Project	IEEE 802.16 Broadband Wireless Access Working Group < http://ieee802.org/16 >	
Title	Corrections for downlink STC in OFDMA PHY	
Date Submitted	2005-01-26	
Source(s)	Yuval Lomnitz Yigal Eliaspur Intel.	Yuval.Lomnitz@intel.com Yigal.Eliaspur@intel.com
	Yigal Leiba Yossi Segal Runcom Ltd.	yigall@runcom.co.il yosis@runcom.co.il
Re:	IEEE P802.16REVd/D5-2004	
Abstract	Corrections and clarifications of definitions for STC in OFDMA PHY.	
Purpose	Adopt changes.	
Notice	This document has been prepared to assist IEEE 802.16. It is offered as a basis for discussion and is not binding on the contributing individual(s) or organization(s). The material in this document is subject to change in form and content after further study. The contributor(s) reserve(s) the right to add, amend or withdraw material contained herein.	
Release	The contributor grants a free, irrevocable license to the IEEE to incorporate material contained in this contribution, and any modifications thereof, in the creation of an IEEE Standards publication; to copyright in the IEEE's name any IEEE Standards publication even though it may include portions of this contribution; and at the IEEE's sole discretion to permit

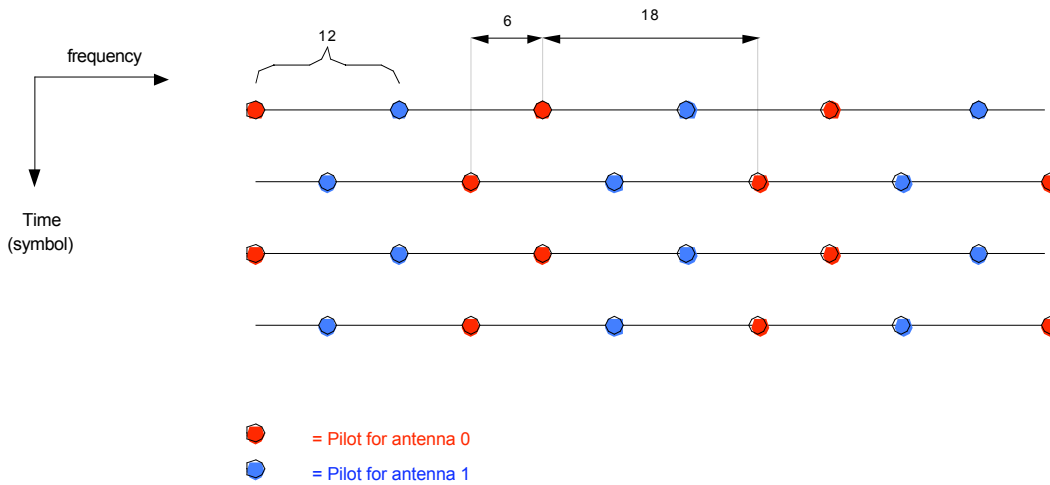
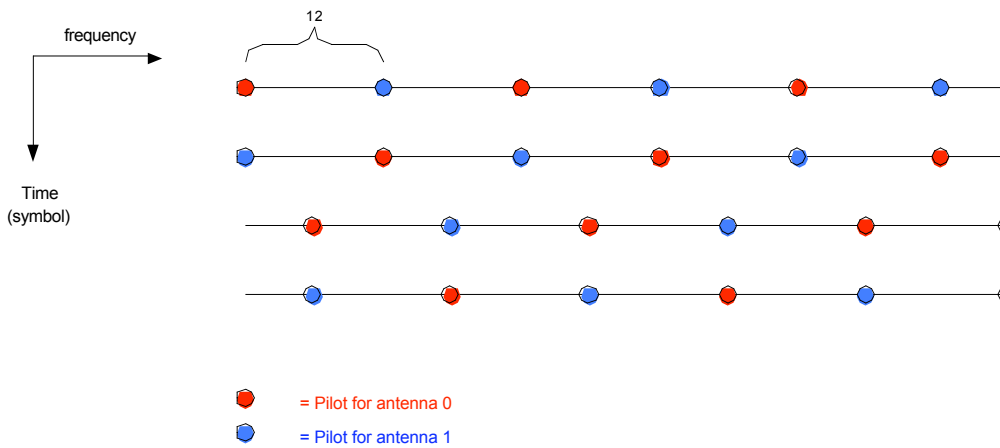
Equation (106) in section 8.4.6.1.2.2 (Symbol Structure for FUSC) defines that FUSC variable pilots are shifted by 6 in each odd symbol. However in STC this creates a problem:

1. Shifting the pilots changes the location of data subcarriers, resulting in the fact that the STC doesn't operate on QAM symbols transmitted in the same frequency. This makes STC combining complex and suboptimal.
2. The operation of STC coding is defined as exchanging tones with the same index for two OFDMA symbols. The STC operation is not well defined when data tones change their locations.
3. The movement of the pilots creates an irregular pilot pattern that doesn't improve channel estimation, as depicted below. It seems that the original intention was merely to exchange pilot-sets between the antennas.

On the other hand, canceling the movement of the pilot will result in regular structure, but will degrade the channel estimation performance (12 tone separation @11Khz carrier spacing = limited to 7us delay spread).

So our proposal is to define that pilot movement is every 2nd symbol.

The maximum pilot spacing over 2 OFDMA symbols is 18 tones (and the minimum is 6 tones)

The pilot spacing (from one antenna) in two OFDMA symbols is 12 tones.

In FUSC all subchannels shall be used for STC transmission, the pilots within the symbols shall be divided between the antennas, antenna 0 uses VariableSet#0 and ConstantSet#0 for even symbols while antenna 1 uses VariableSet#1 and ConstantSet#1 for even symbols, antenna 0 uses VariableSet#1 and ConstantSet#0 for odd symbols while antenna 1 uses VariableSet#0 and ConstantSet#1 for odd symbols (symbol counting starts at the starting point of the relevant STC zone), defined in 8.4.6.1.2.2. ~~In STC transmission the $FUSC_SymbolNumber$ in equation (106) is replaced with $\text{floor}(FUSC_SymbolNumber/2)$, so~~

that variable pilots shall move every 2nd symbol. The transmission of the data shall be performed in pairs of symbols as illustrated in Figure 247.

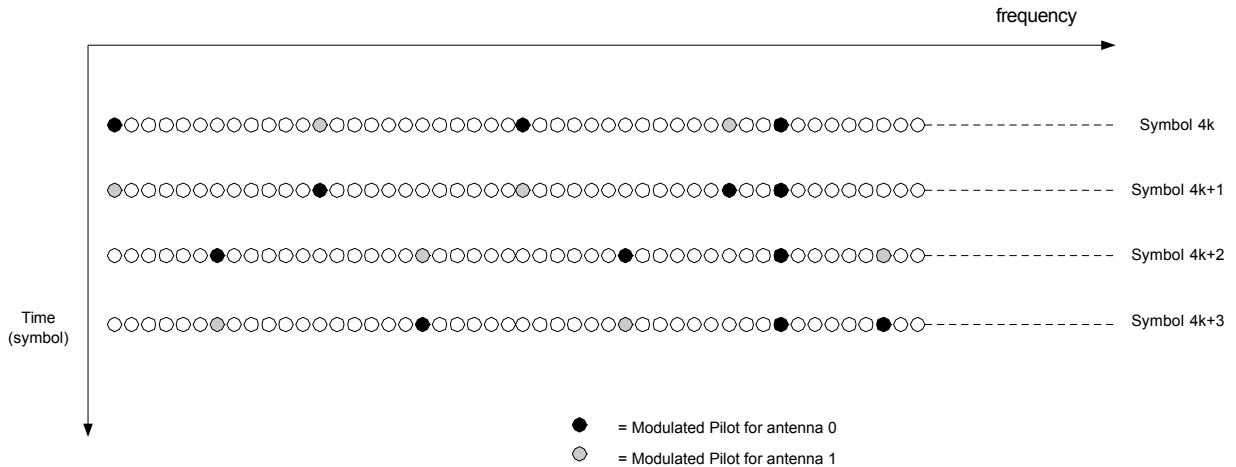
~~The structure shall be modified as depicted in Figure 245 (switching 2 pilot carriers from the odd symbol with 2 data carriers from the even symbols, switching of the data carriers and the pilots carriers shall be performed after constellation mapping and before STC encoding defined in 8.4.8.1.2.1 and subcarrier randomization defined in 8.4.9.4.1,~~

Figure 251a: STC usage with FUSC for 4 antenna configuration

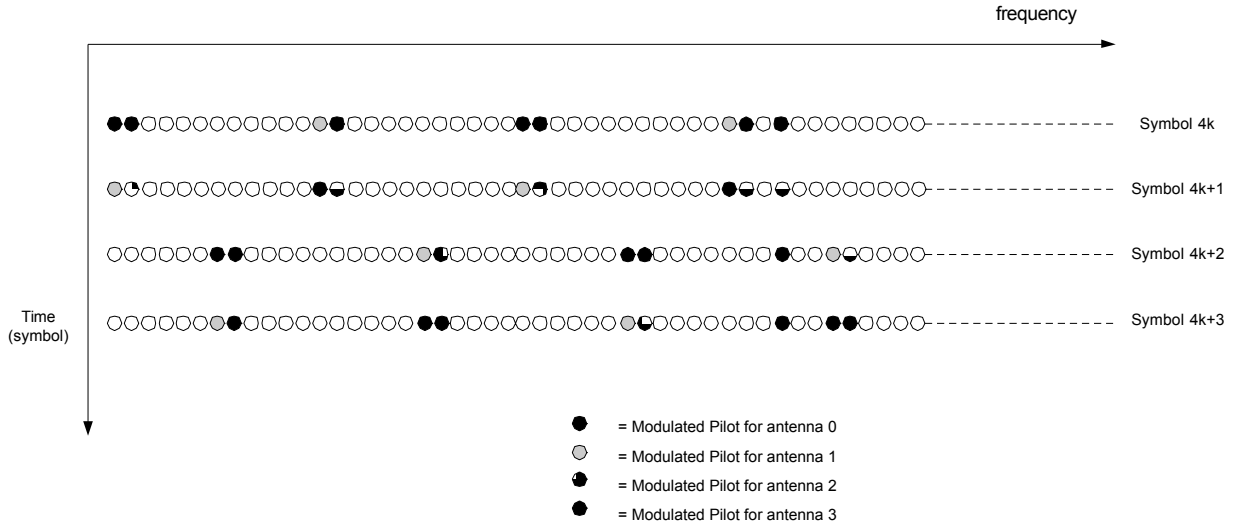
Even Symbols 0: antenna 0 uses VariableSet#0 and ConstantSet#0, antenna 1 uses VariableSet#1 and Constant-Set#1, antenna 2 uses indices of (VariableSet#0+1), antenna 3 uses indices of (VariableSet#1+1)

Odd Symbols 1: antenna 0 uses VariableSet#1 and ConstantSet#0, antenna 1 uses VariableSet#0 and Constant-Set#1, antenna 2 uses indices of (VariableSet#1+1) and (ConstantSet#0), antenna 3 uses indices of (VariableSet#0+1) and (Constant-Set#1)

Symbol 2: antenna 0 uses VariableSet#0 and ConstantSet#0, antenna 1 uses VariableSet#1 and Constant-Set#1, antenna 2 uses indices of (VariableSet#0+1), antenna 3 uses indices of (VariableSet#1+1)

Symbol 3: antenna 2 uses VariableSet#1 and ConstantSet#0, antenna 3 uses VariableSet#0 and Constant-Set#1

In STC transmission the *FUSC_SymbolNumber* in equation (106) is replaced with $\text{floor}(FUSC_SymbolNumber/2)$, so that variable pilots shall move every 2nd symbol.

The FUSC permutation is performed on the data subcarriers remaining after allocating the pilots for antennas 0,1 and the Constant pilots. The data subcarriers which overlap with variable pilots allocated to antennas 2,3 are punctured replaced with pilots (replaced with the pilot subcarrier).

[Add figure 251a for illustration]
